# ADMINISTRATIVE AMENDMENT

| KEYED NOTES                   |   |
|-------------------------------|---|
| Classrooms and Gathering Hall |   |
| CHURCH of the RISEN SAVIOR    |   |

Risen Savior Addition  
and Renovation

**SITE PLAN**  
1" = 30'-0"

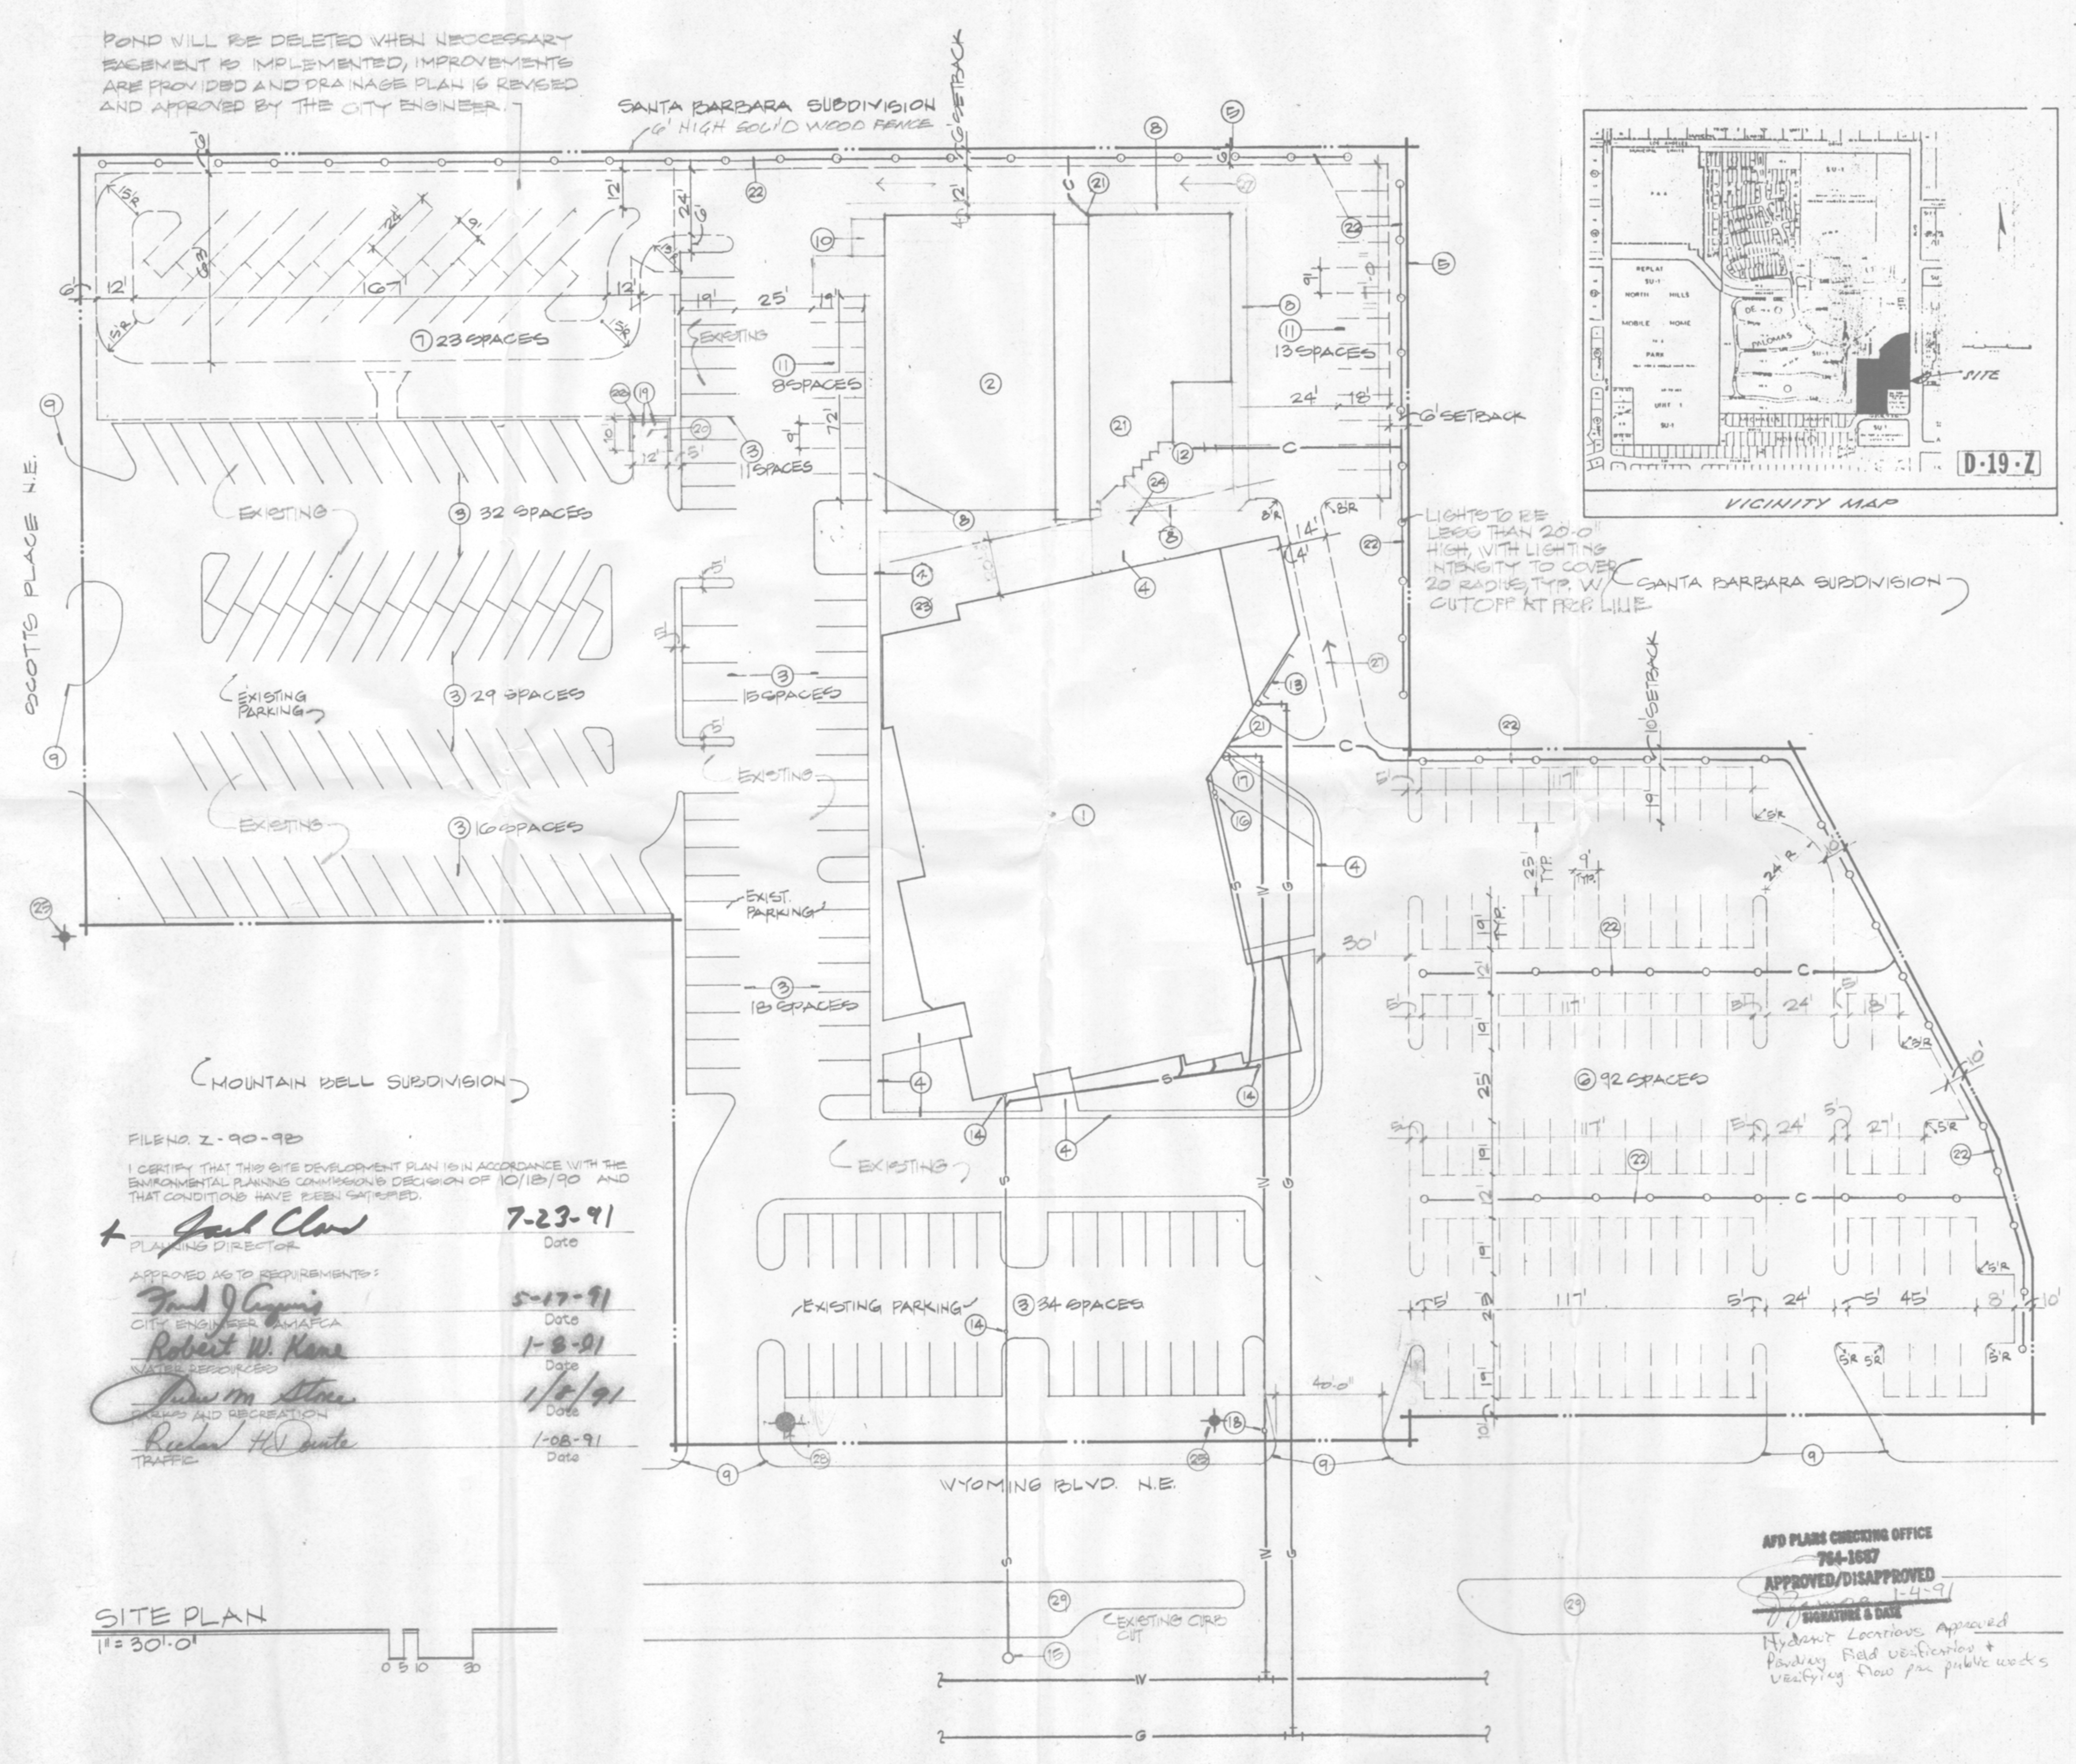
POND WILL BE DELETED WHEN NECESSARY EASEMENT IS IMPLEMENTED, IMPROVEMENTS ARE PROVIDED AND DRAINAGE PLAN IS REVISED AND APPROVED BY THE CITY ENGINEER.
